**SERVICE BULLETIN**

**APPLICABILITY:** 2019-21MY Forester

**NUMBER:** 12-237-22

**SUBJECT:** Loose Fitting Side Windshield Cowl Panels

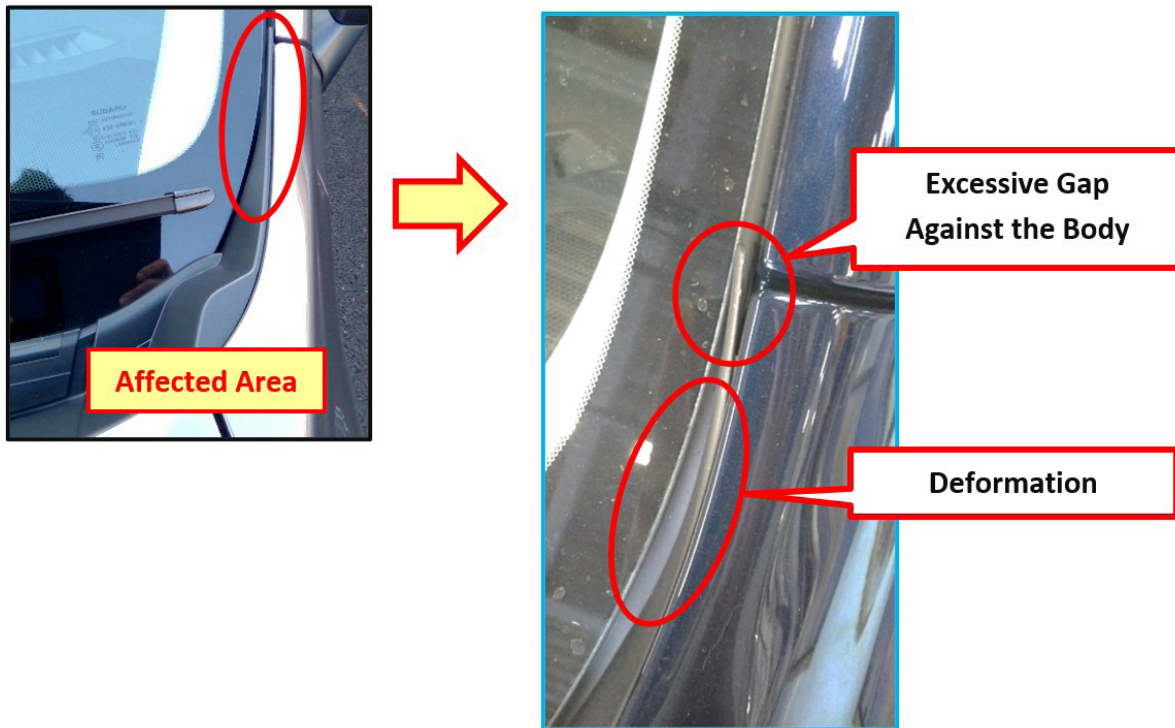
This bulletin announces the design change made to the side cowl panels. A fortified building material has been introduced into production to avoid any possible panel deformation. This was initiated to address the small number of cases of the side cowl panels having an excessive gap against the body or exhibiting a “loose fitting” appearance. If any panel deformation is confirmed, replace the affected panel(s) with the new part.

The new parts have been incorporated into production of the Forester as of the starting VIN **MH576492**.

Part Description	Part Number
COWL PANEL-SIDE,RIGHT	91423SJ002
COWL PANEL-SIDE,LEFT	91423SJ012
